Memorandum

Date: 21 August 2018
To: Scott Miller
U.S. Environmental Protection Agency Region 4
From: Steven Poirier, P.E., Geosyntec Consultants
Subject: Response to comments (RTC) on the Cabot Carbon Superfund Site 50% Remedial Design Report.
Gainesville, Florida

The following are responses to comments received from the U.S. Environmental Protection Agency (US EPA) and stakeholders on the Cabot Carbon Superfund Site 50% Remedial Design Report, dated 6 July 2018. These responses pertain specifically to design-related comments received. Other non-design-related comments have been reviewed, are acknowledged, and can be discussed further upon request.

Figure 8. Hydraulic conductivity vs. 2 μ m clay content.

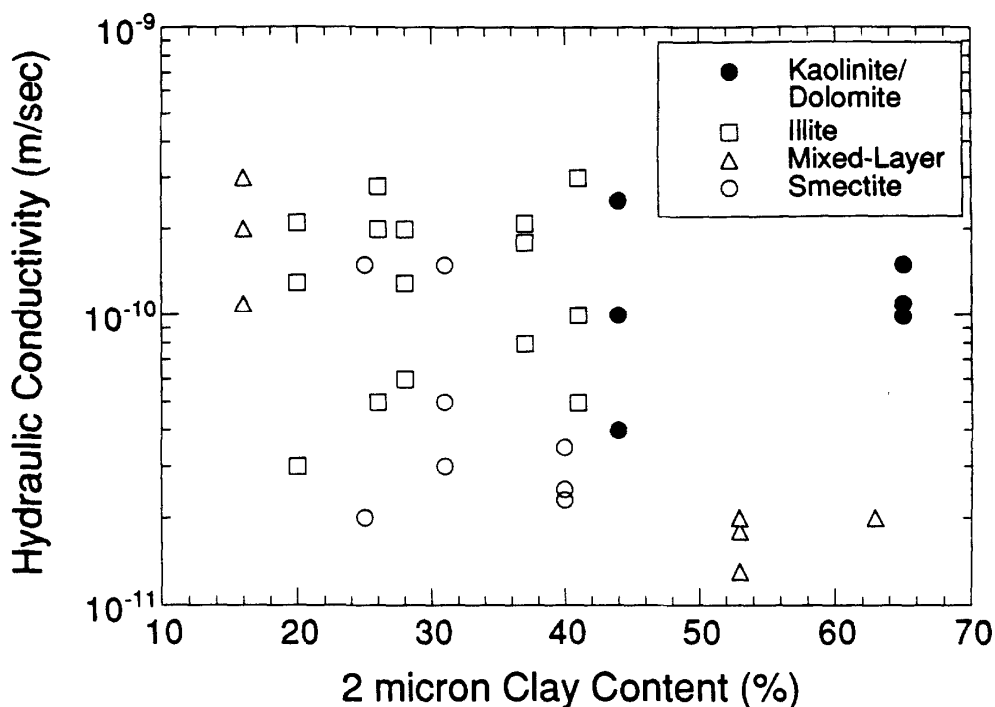
GRU Comment No. 6 - Section 2.7 – Site Stratigraphy, Bullet #5: *Has the vertical and horizontal permeability of the MHG Clay been documented in the area within the footprint of the proposed VBW? The MHG clay that was penetrated by some of the Cabot VBW borings appears to be coarser – and to contain more sandy layers – than the MHG clay observed at the Koppers Site. How might these sandy lenses affect performance of the remedy and how would that performance be monitored?*

Response: Cabot appreciates the observations about the composition of the middle clay at the Site. The hydraulic conductivity of the middle clay was not tested during the pre-design investigation. However, based on the material observed during the drilling program, the Cabot team does not expect sand content or layers in the middle clay layer (referenced in your comment as the “MHG clay”) to impact the design for several reasons:

- The hydraulic conductivity of a soil is generally insensitive to the percentage of fine-grained material when the fines content (i.e., mass fraction passing the No. 200 sieve) is greater than about 15%. An example of this is shown in the figure below from Benson and Trast (1995)¹. Samples of the middle clay from the pre-design testing had 58% to 98% fines.

- Historical data indicate that middle clay has an average thickness of about 15 feet and a horizontal hydraulic conductivity of 0.0029 ft/day to 0.0033 ft/day (1.2×10^{-6} cm/s) for soil samples collected at boring SB12-65-70 at depths of 65.3 ft and 68.4 ft, respectively (SRI/FFS Report, Gradient 2017). The vertical hydraulic conductivity of the middle clay is likely lower. Therefore, based on experience with vertical barrier wall design and construction, the middle clay layer is a suitable unit with a low hydraulic conductivity.

- Pumping within the VBW is included as a component of the remedy to limit groundwater migration through the middle clay, both horizontally and vertically.
